## Further objections in respect of the Development Application for 23 Hay Street Collaroy (DA2021/1824)

Submitted on behalf of Simon and Emilie Burns [REDACTED].

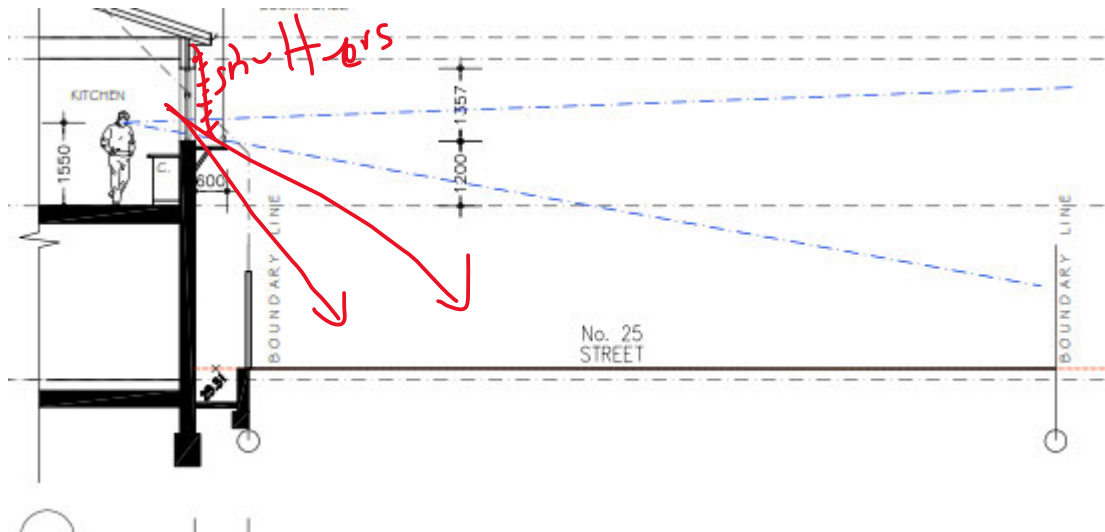
We note that the amended plans remove the “shelf” in previous plans which operated to block some (but not all) viewing into the private open space, and replaces it with Bahama shutters.

The previous plan included the below diagram – which was proposed by the applicant to indicate that the view into 25 Hay Street’s private open space was through a low angle which would be blocked by the shelf. We agreed that the shelf would block the view at certain angles, but by itself was insufficient.

The irony of the current revised proposal, is that the shelf is removed, and instead that angle of view is completely open to our private outdoor space, instead the shutters block the different angle. So again, it is only half a solution. We also note that if the shutters angle 45% down, that angle will completely enable viewing into our private open space, and will not provide any privacy protection.

- The shelf be reinstated in addition to the shutters;
- The Shutters have deep blades (at least 10cm long), that are angled 60% up – so, including when the shutters are closed, they do not permit viewing down into our property (but let light into 23 Hay).

- The shutters should not be able to be opened so that the opening is more than 30cm across the bottom.

## 5 Front set-back

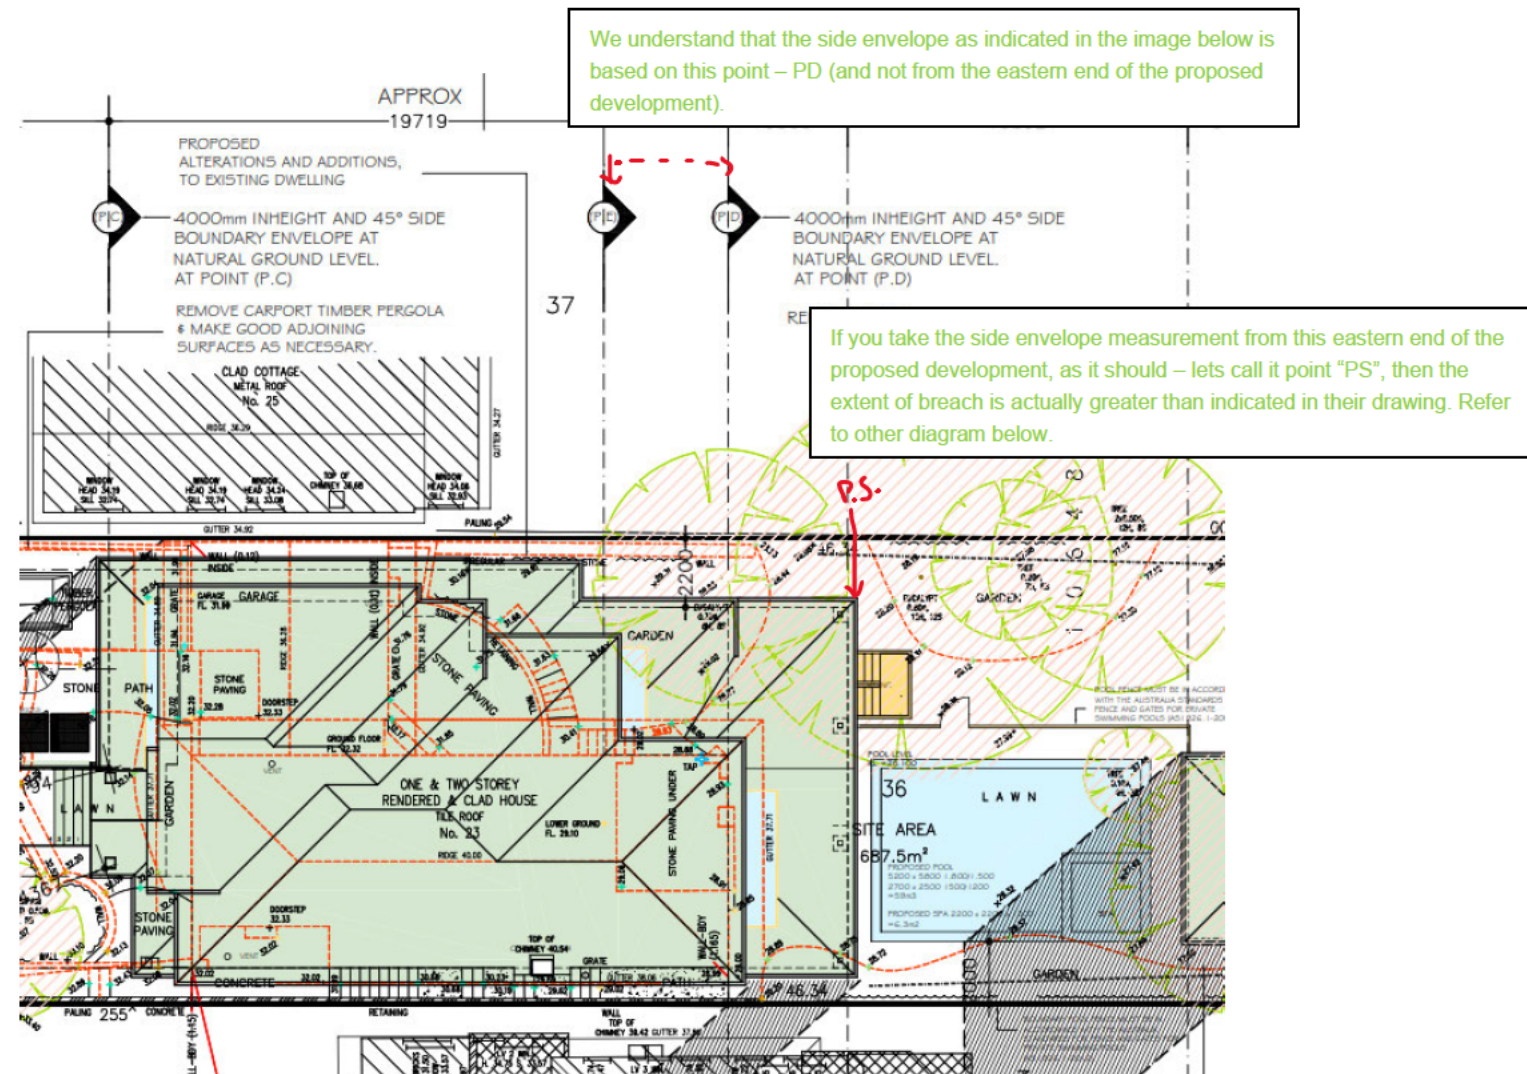
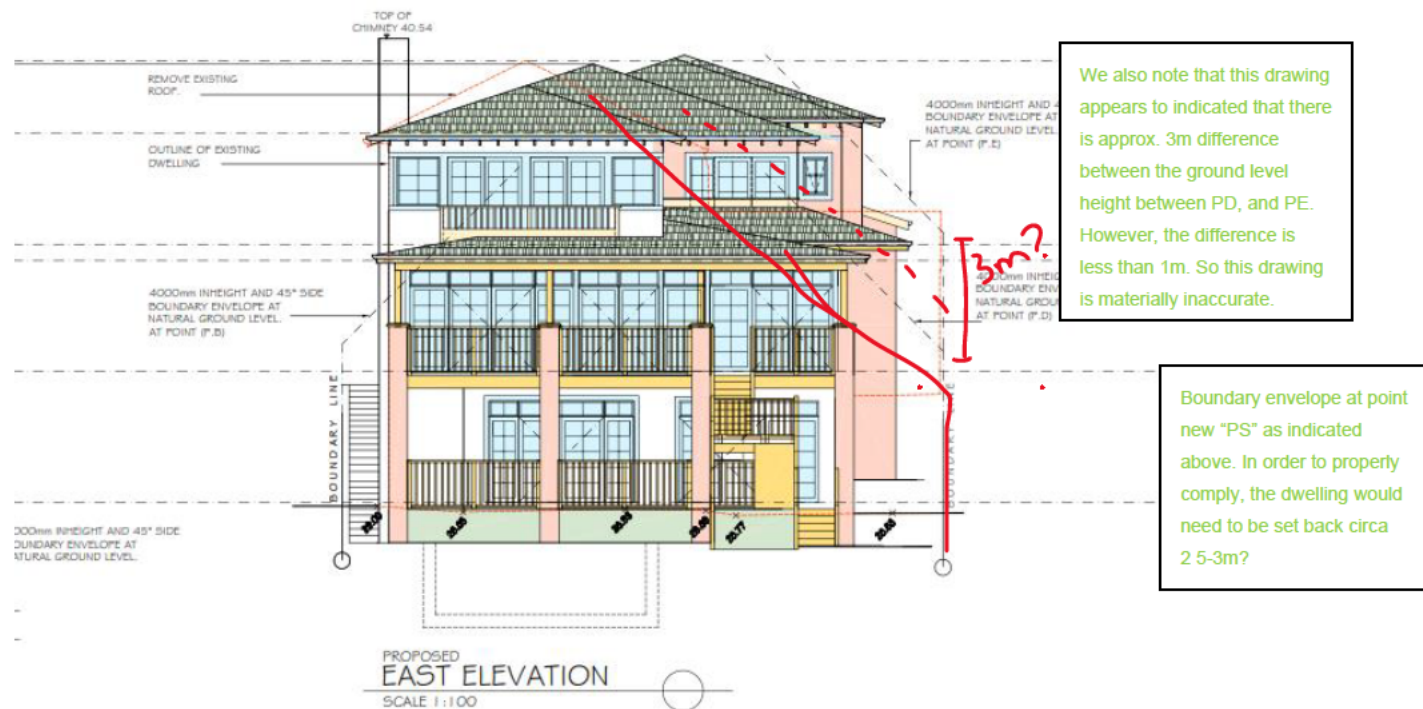
In addition to our prior objections with respect to the front garage and its positioning on top of our children's bedroom, we note that the proposed development encourages on the front setback established by 27 Hay Street, 25 Hay Street to the north, and 21 Hay Street to the South. This encroaching of the property forward is not necessary or justified, and together with the excess bulk and scale, and reduction of landscaping and trees, creates and out of character and imposing development that is inconsistent with its surrounds.
